Lighting:  
 Section 6.2.3 of the LDC

Project Name: 7630 Ben Grass Meadow Drive

SR-34229

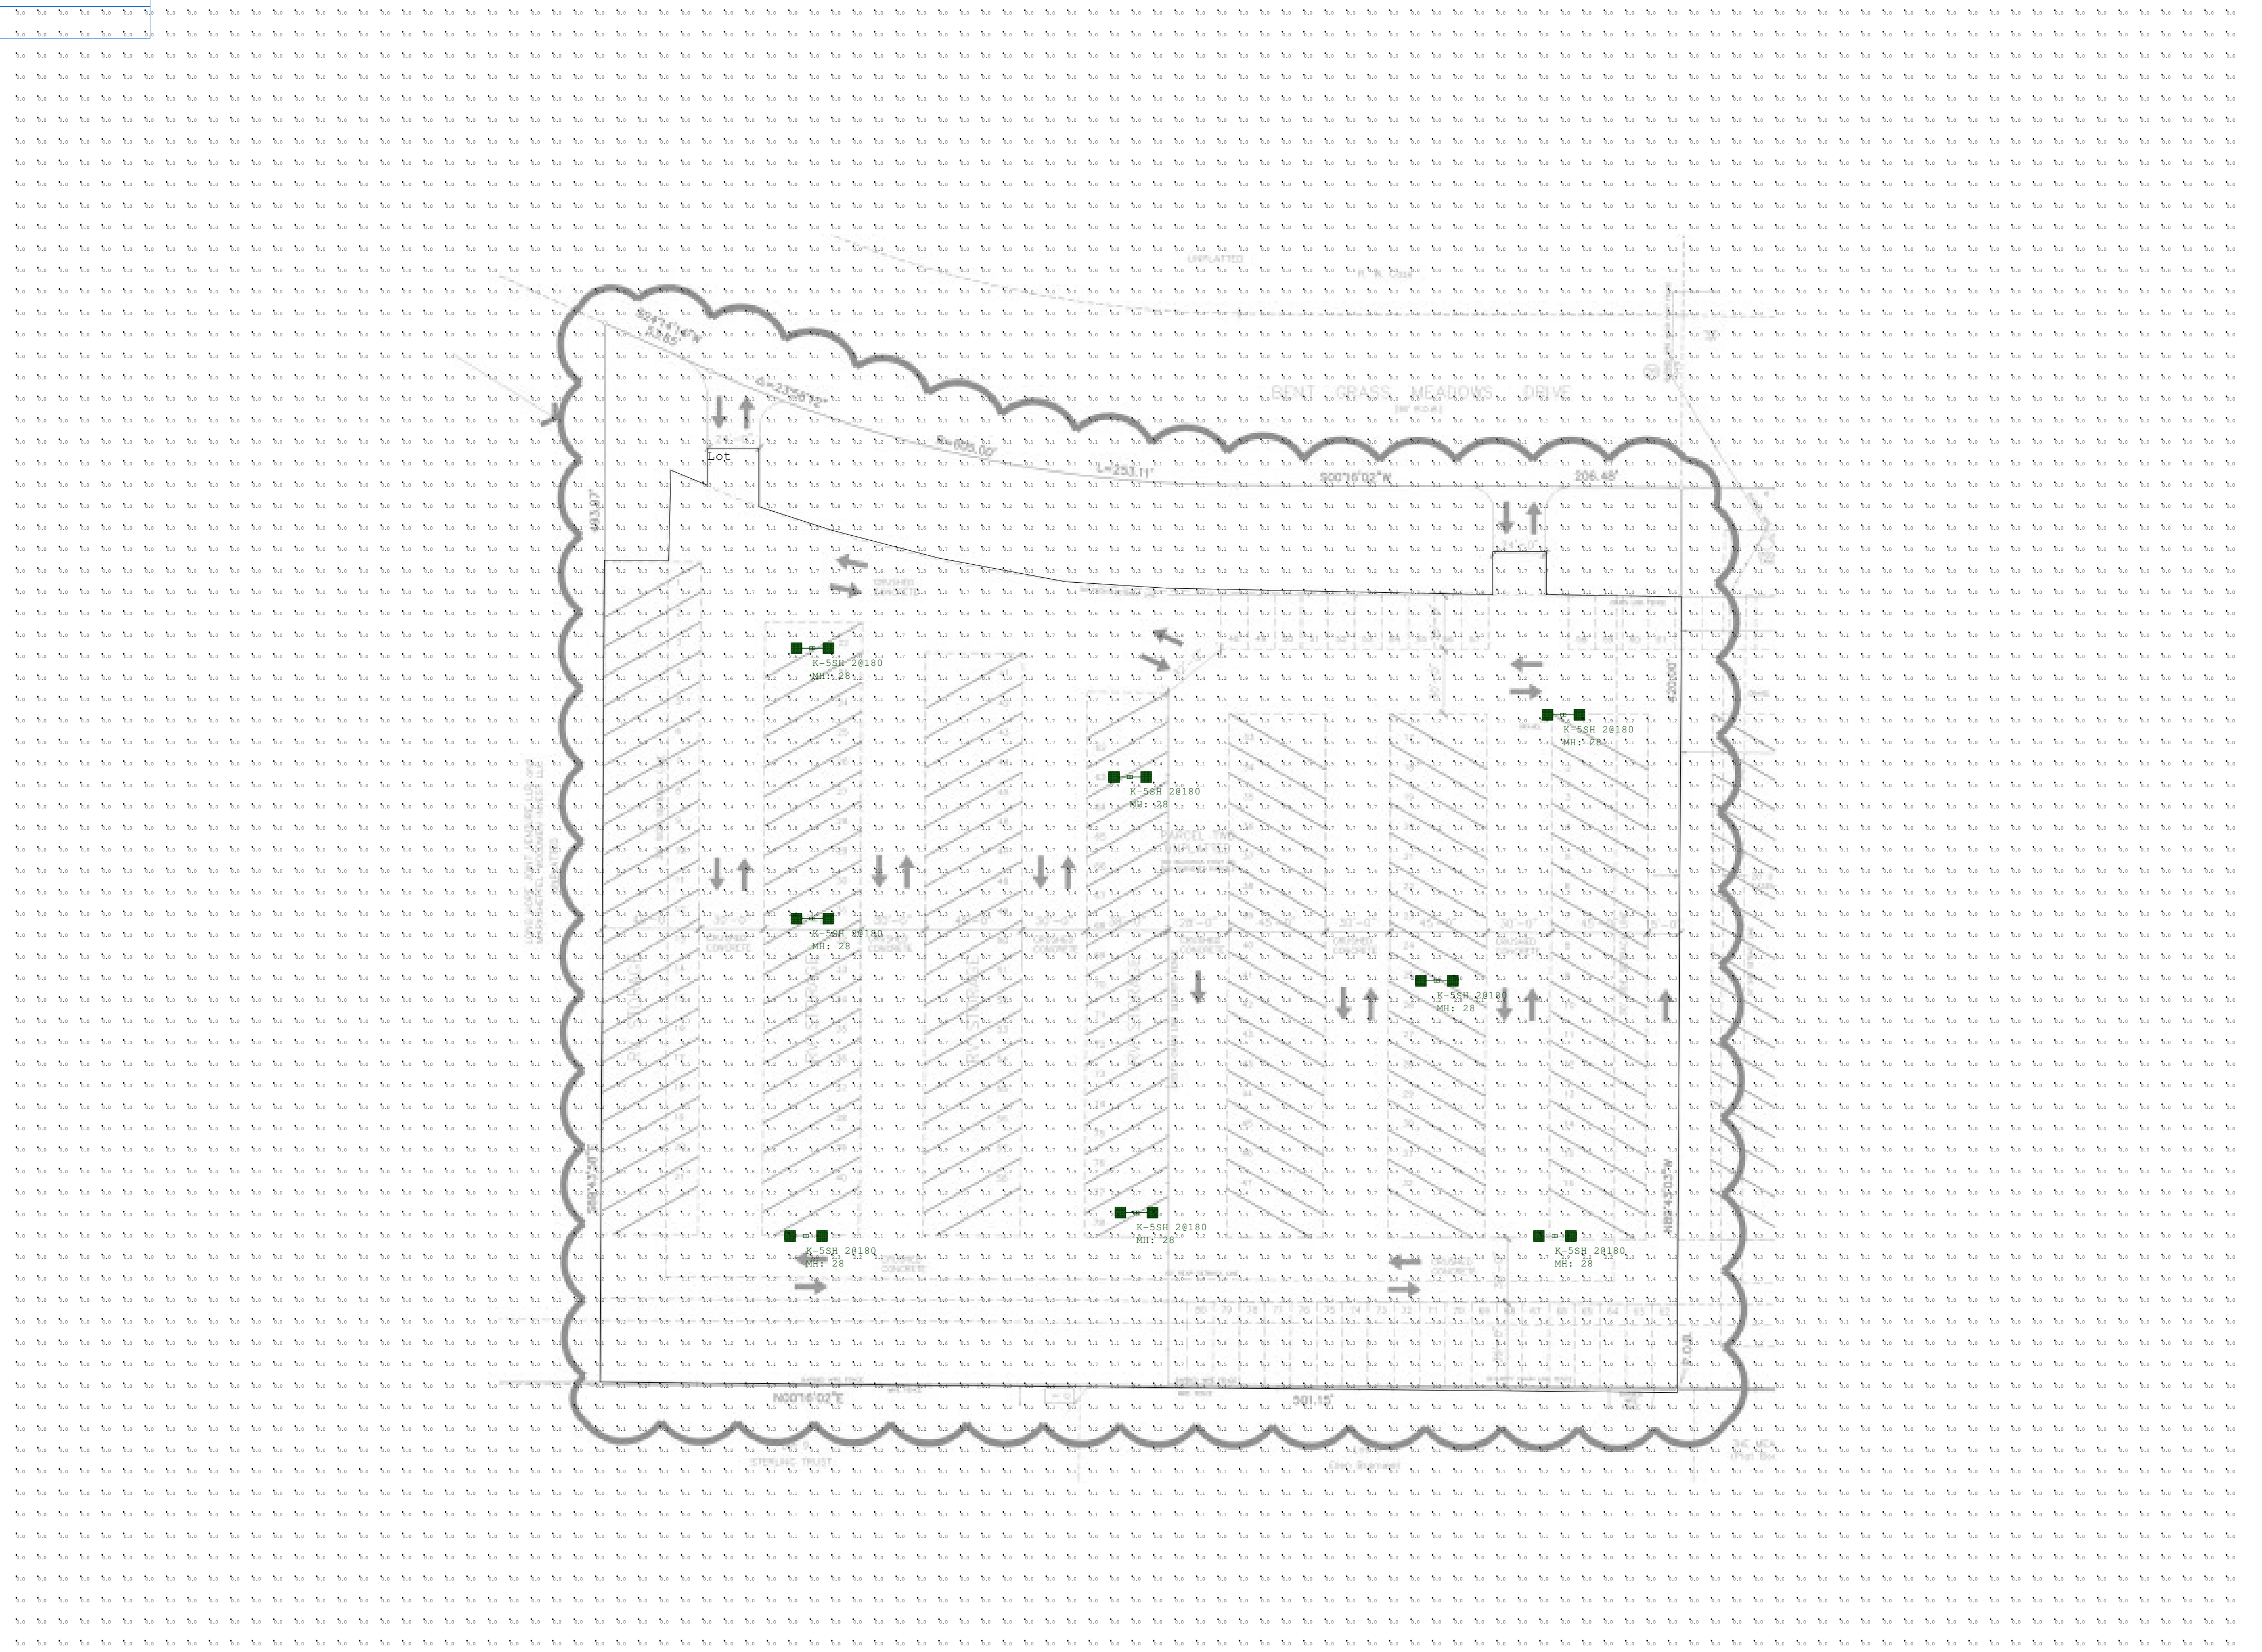
-Please depict the owner/applicants: name, phone number, and email  
 -Please depict a north arrow on this plan  
 -Cannot exceed a maximum height on 20 ft, if you plan to exceed please follow alternative lighting plan requirements and state in letter of intent  
 -Location of all existing and proposed easements, if there are none, please specify
